CITY OF NEWPORT BEACH

April 12, 2017

Re: Request for Revision of the Preliminary FIRM and BFE
Docket No. FEMA-B-1673

Figure 1. Sea Wall Survey Locations

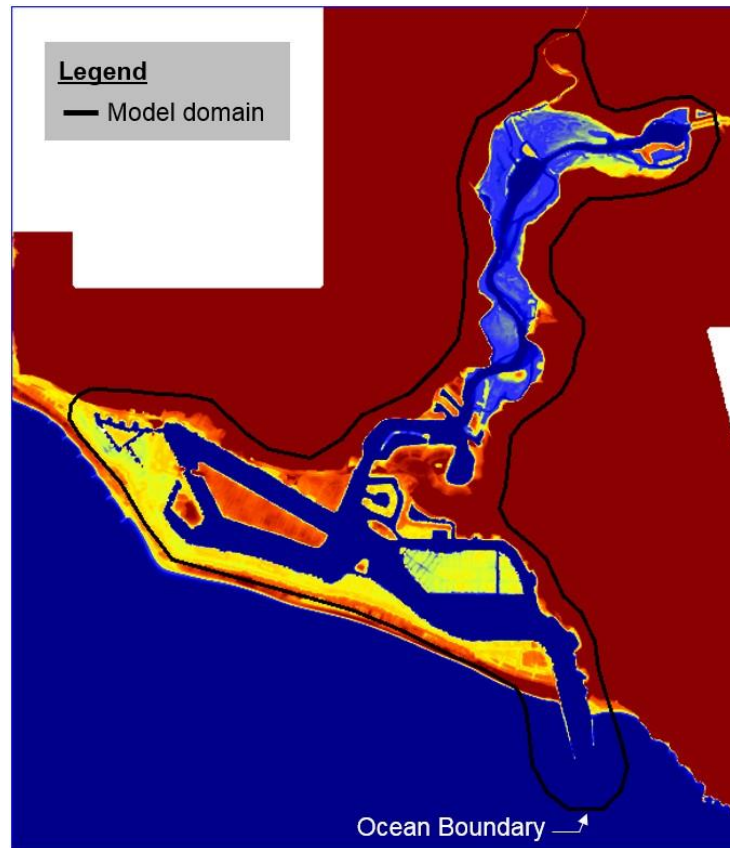
Within the Newport Bay and Harbor, most of the bayside shorelines along the Newport Peninsula and the entire Balboa Islands are protected from flooding by seawalls. Figure 1 shows the locations where seawall survey data was available and should be considered in the mapping of the flood boundaries. As shown in the figure, seawall elevation data for the Balboa Islands was collected by a Licensed Civil Engineer in 2010 and the data along the bayside shorelines was conducted by a licensed surveyor in 2017. This data is provided in the DVDs that accompanied this letter, under the folder titled "Seawall Data."

Figure 2. HEC-RAS Model Setup

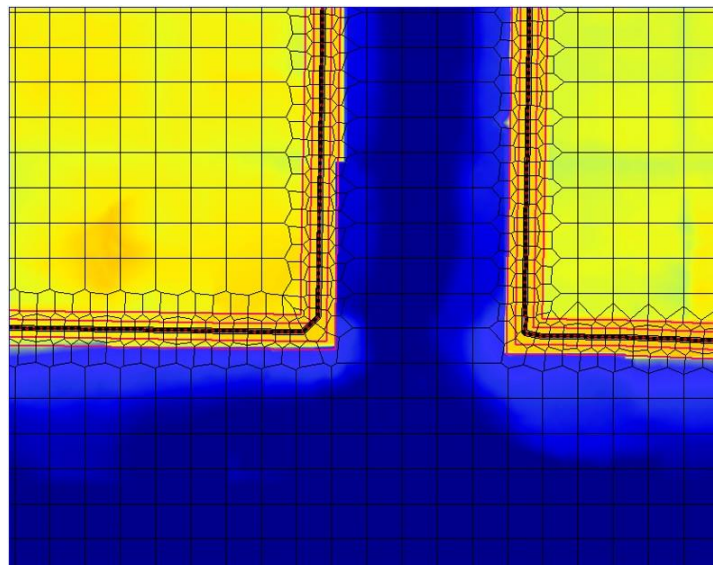
We believe that the use of 2D hydrodynamic modeling is critical for providing accurate flood mapping for the AE Zone of Newport Bay and Harbor. Hence, we used the FEMA-approved HEC-RAS model (version 5.0) to conduct flood modeling of the Newport Bay and Harbor. HEC-RAS version 5.0 includes 2D flood routing capabilities and allows a time-varying stage hydrograph, which is used to simulate tidal forcing at the ocean boundary. Figure 2a shows the HEC-RAS model domain for the Newport Bay and Harbor. In setting up the model, we started with the Newport Beach topographic data used in the Open Pacific Coast (OPC) Study provided by Ms. Karin Ohman, and added the seawall elevation survey data to the model. As an example of the model grid setup with the seawall data, Figure 2b shows a zoomed view of the computational mesh and the modeled seawall surrounding the corners of Balboa Island and Little Balboa Island.

Figure 3. Tides Applied at the Ocean Boundary of HEC-RAS Model

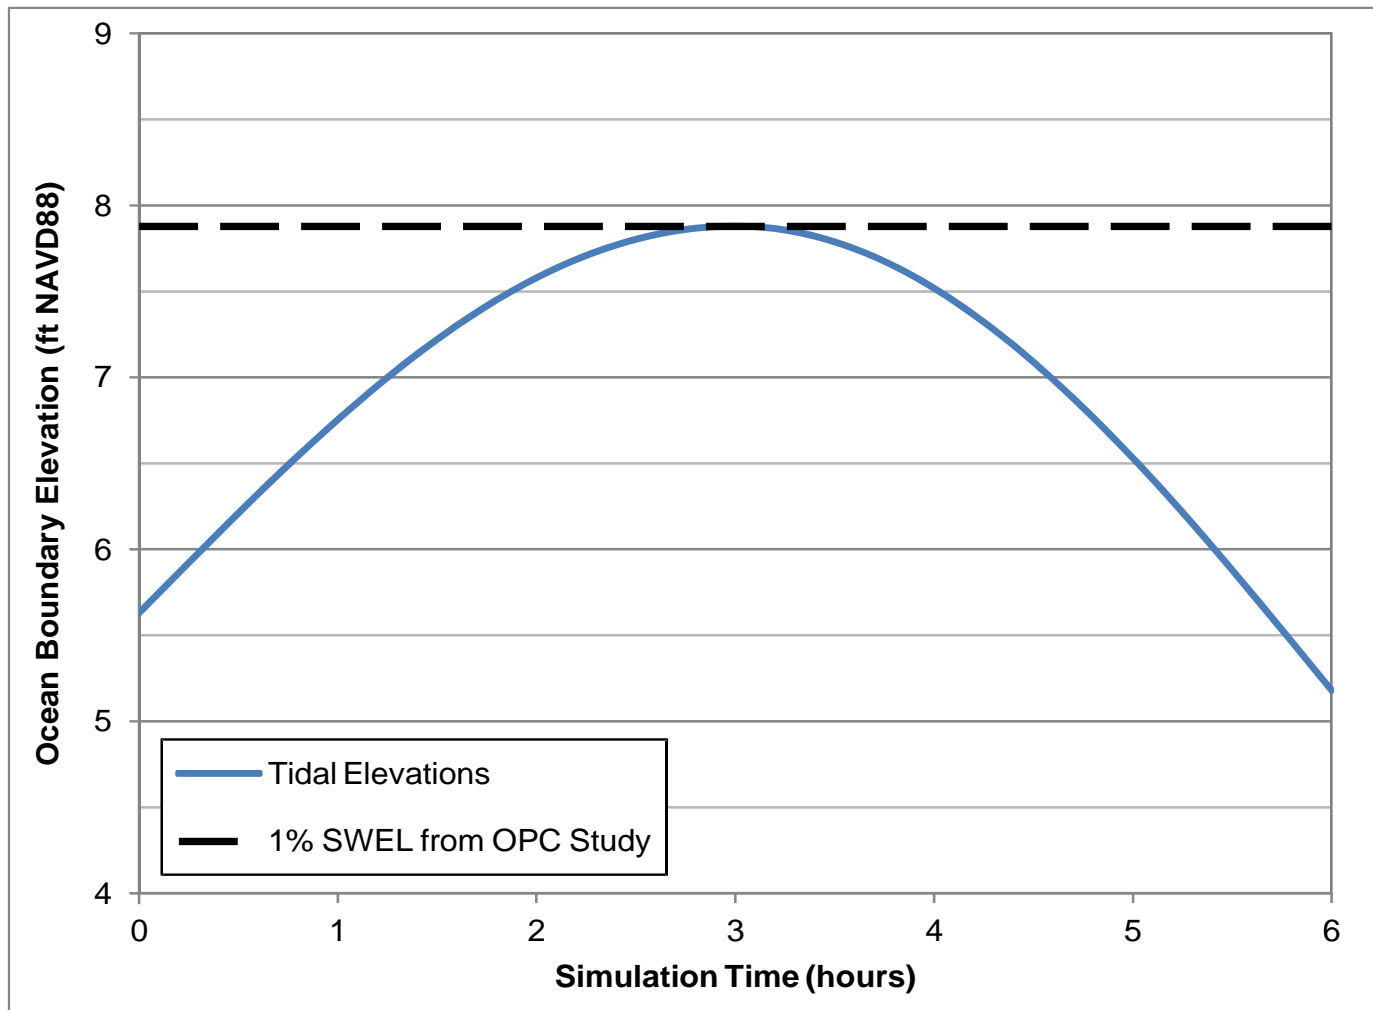
To map the AE Zone in Newport Bay, a 6-hour simulation was conducted using a 6-hour tide (shown in Figure 3), specified as a time-varying stage hydrograph at the ocean boundary of the model domain. As shown in Figure 3, the tide has a peak at 7.88 ft, NAVD, which is consistent with the 1% still water elevation (SWEL) determined for Newport Bay in the OPC study (IDS#4, Table A-2). The boundary of the AE Zone was defined as the extent of flooding predicted by the HEC-RAS model. In Figure 4, we compared the flood zone areas of the AE Zone that were predicted by the HEC-RAS model and the preliminary FIRM. In the figure, the top panel (Figure 4a) shows the AE Zone that was mapped in the OPC study using the bathtub approach, while the bottom panel (Figure 4b) shows the AE Zone mapped using the HEC-RAS model. As can be seen in the figure, the bathtub approach to mapping predicts a larger flooding extent compared with an approach using the HEC-RAS model. This finding is consistent with the findings in Gallien et al. (2011). Since the bathtub approach over predicts inundated areas, we request that the Preliminary FIRM for the AE Zone be revised based

Figure 4. Comparison of Preliminary FIRM AE Zone with the Proposed Revised Flood Zone

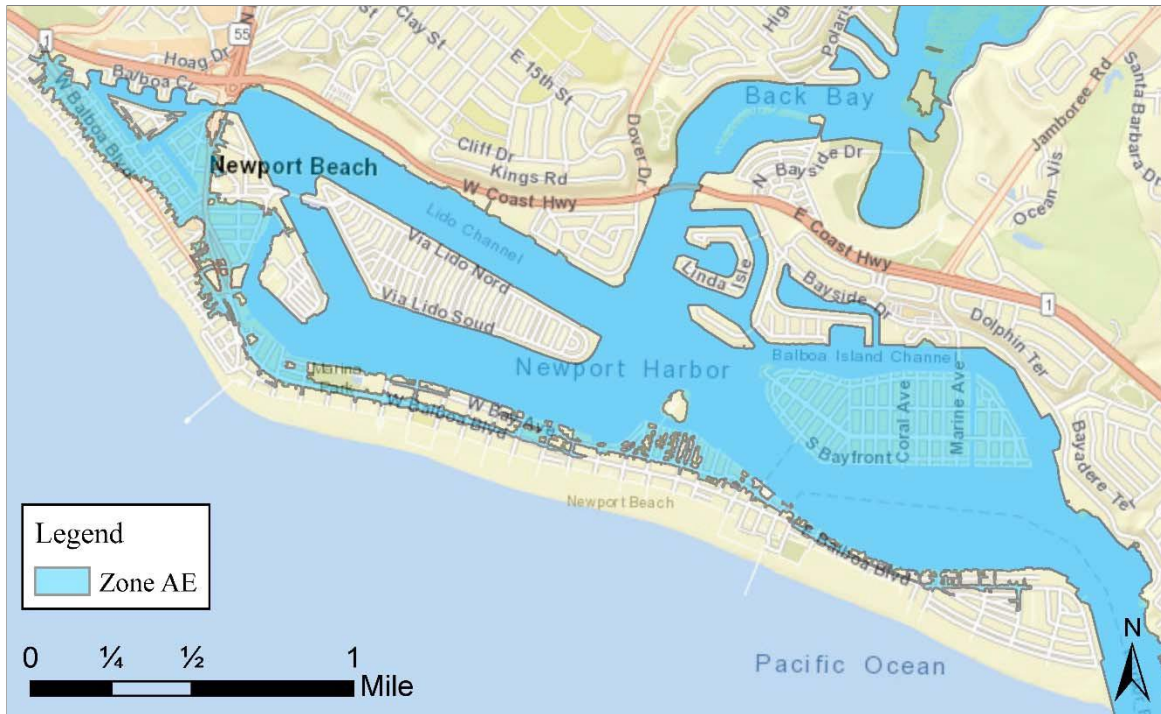
on the more accurate 2D model results which have also incorporated the seawall elevations along the shoreline.

1. Revise the FIRM for the AE Zone to the proposed revised flood map shown in Figure 4b, which was developed based on more accurate 2D hydrodynamic modeling.
2. For the VE Zone, revise the BFEs to those shown Table 1. The proposed revised BFEs were developed based on more accurate use of the available beach slope data. In addition, revise the preliminary FIRM for Zone 16, 17, 18, 20, 22 and 23/24 to the proposed revised VE Zone extents shown in Figures 9 to 14.

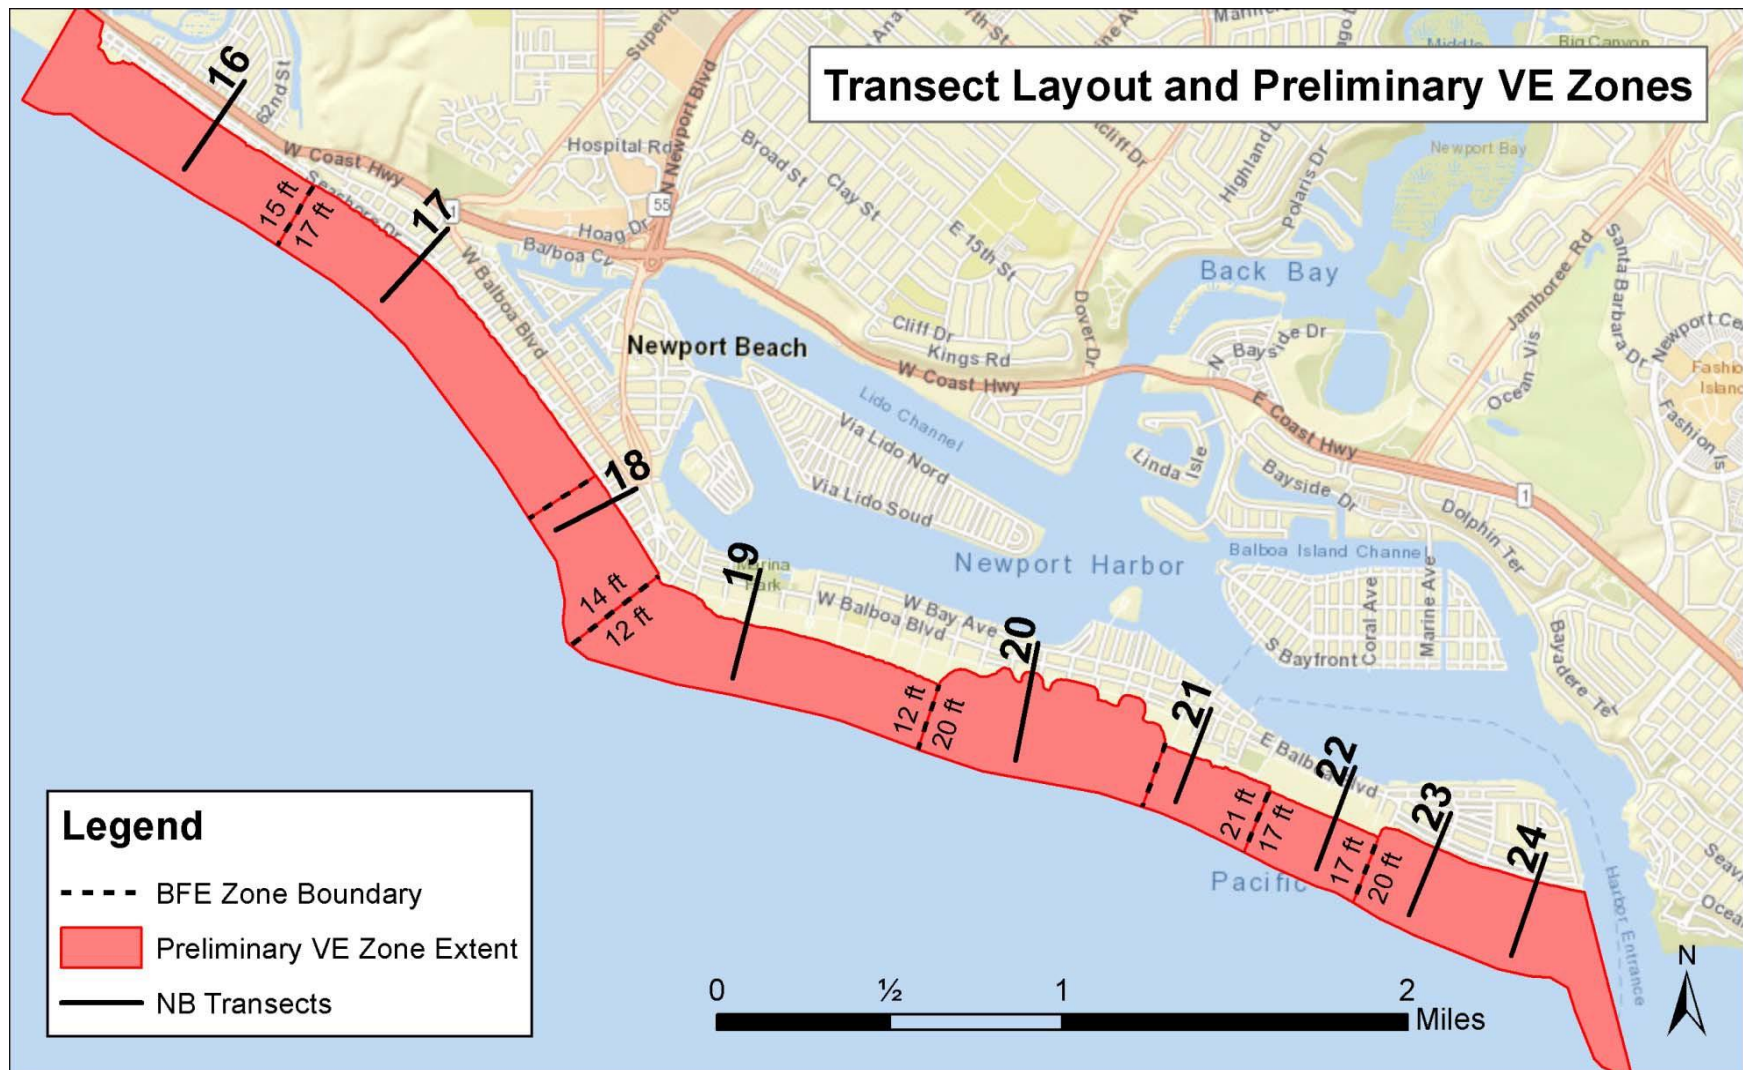
As shown in Figure 5, the OPC study used only a few beach transects to represent the entire Newport Beach Coast; this means that a single beach slope taken at each transect is being used to define an extended shoreline reach. We understand that for mapping purpose it is reasonable to represent the shoreline with limited number of BFE Zones. However, since there is significant variability in foreshore beach slope within shoreline reaches, it is more realistic and reasonable to use the average beach slope—instead of using only a single beach slope where the transect happens to be located—along each reach to calculate the corresponding BFE for that shoreline reach.

Figure 6. The foreshore slopes of the transects used in the OPC Study compared to the transect slopes calculated at 200 ft increments

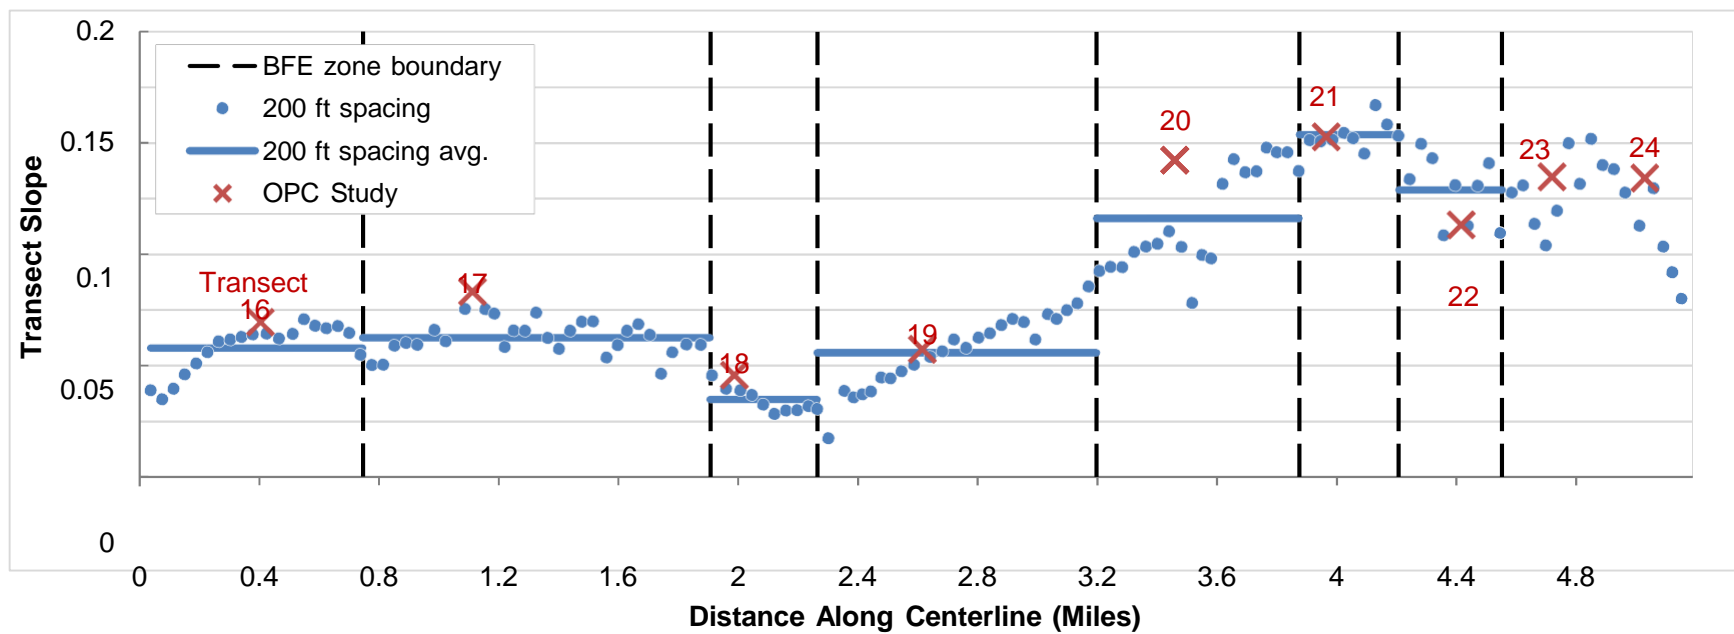
Figure 6 shows the foreshore beach slope of OPC transects 16 to 24 as compared with beach slopes determined at 200 ft (61 m) spacing. Also shown in Figure 6 are the average beach slopes within each shoreline reach, which were calculated using the transects taken at 200 ft (61 m) intervals. The boundaries of shoreline reaches, which define changes in BFEs, are shown in Figure 6 as *black* dashed lines. The OPC foreshore beach slopes of transects 16, 17, 18, 20, 23, and 24 are generally larger than the average foreshore slopes in their respective reaches. Since the BFEs are assigned to an entire shoreline reach, and there is significant variability in transect slopes within reaches, the open coast BFEs in the Newport Beach area should be determined using the average transect slope within each shoreline reach.

Figure 7. BFE calculated using the average slope within each shoreline reach (blue line) compared to the BFE calculated in the OPC study (*red* line)

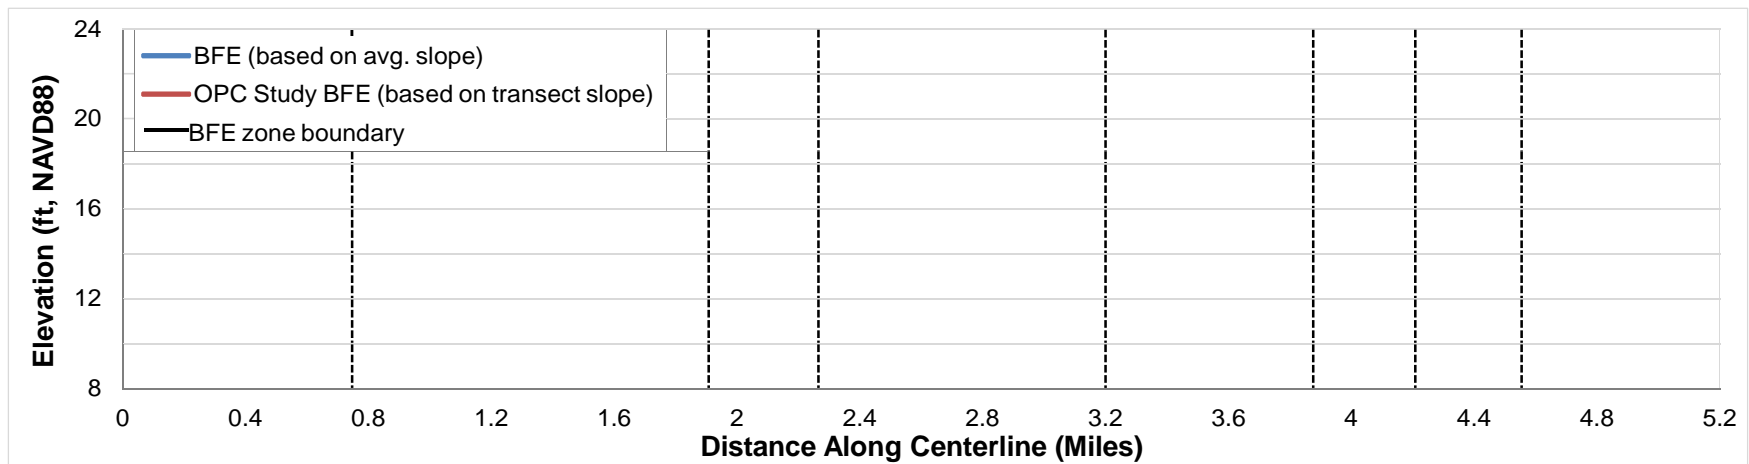
Figure 7 compares BFEs calculated based on the average reach slopes using the methods detailed in the OPC Study, with the BFEs reported in the OPC Study calculated using a single beach slope

taken at a transect. As shown in the figure and in Table 1, using the average reach slope in the BFE calculations results in lower BFEs for shoreline reaches at transects 16, 17, 18, and 23/24. For reach 22, use of the average slope resulted in a higher BFE. We request that the open coast BFEs be revised to reflect the values determined using average reach slopes, which are presented in Table 1 below.

Figure 9. Proposed Revised VE Zone Extent for Zone 16

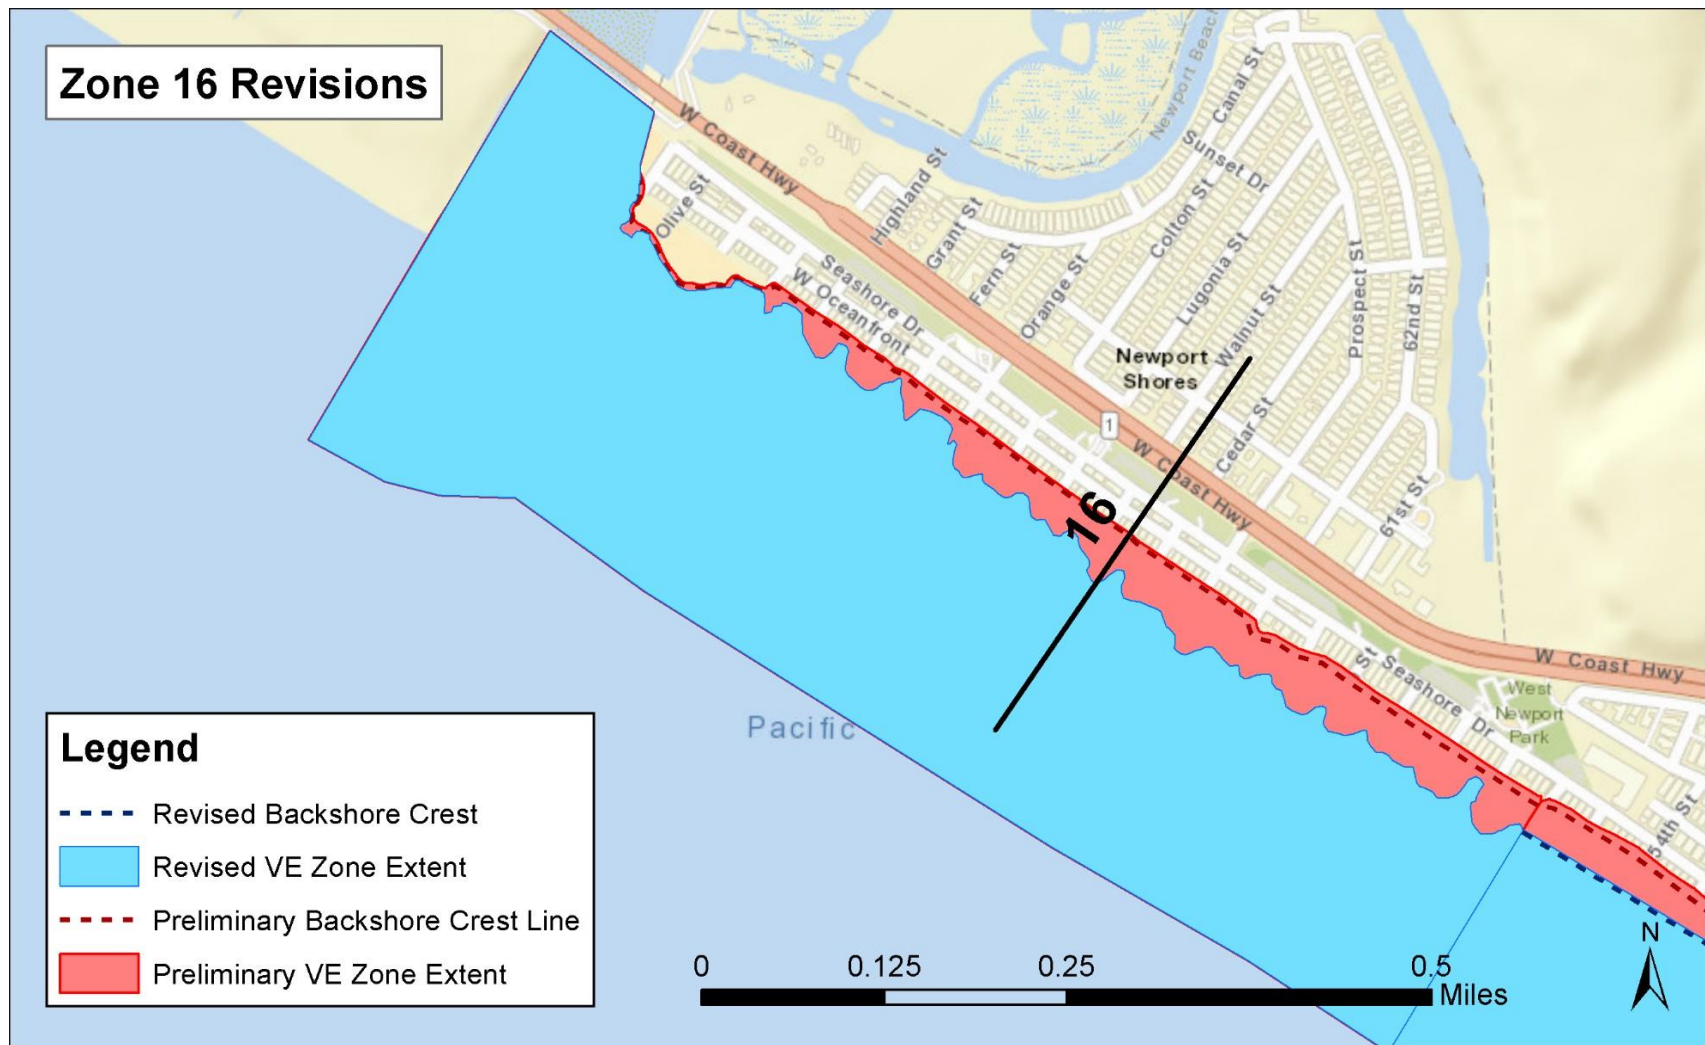
In Zone 16, the preliminary 1% TWL overtops the foreshore beach crest and backshore beach profile. The VE Zone extent was therefore, based on backshore overtopping analysis in the OPC Study. However, the revised 1% TWL in Zone 16 is not high enough to overtop the backshore dune. Since the revised 1% TWL does not overtop the dune, the revised VE Zone extent is defined as the intersection of the beach dune and 1% TWL. This is consistent with the OPC Study's methodology, where in cases when a backshore feature is high enough not to be overtopped, "the TWL is projected to the base of that feature." Thus, in the revised Zone 16, backshore-overtopping analysis was not conducted. Figure 9 shows the revised versus preliminary VE Zone extents. The change in VE zone extent is based solely on the revised 1% TWL, which reflects the average foreshore beach slope of shoreline reach 16.
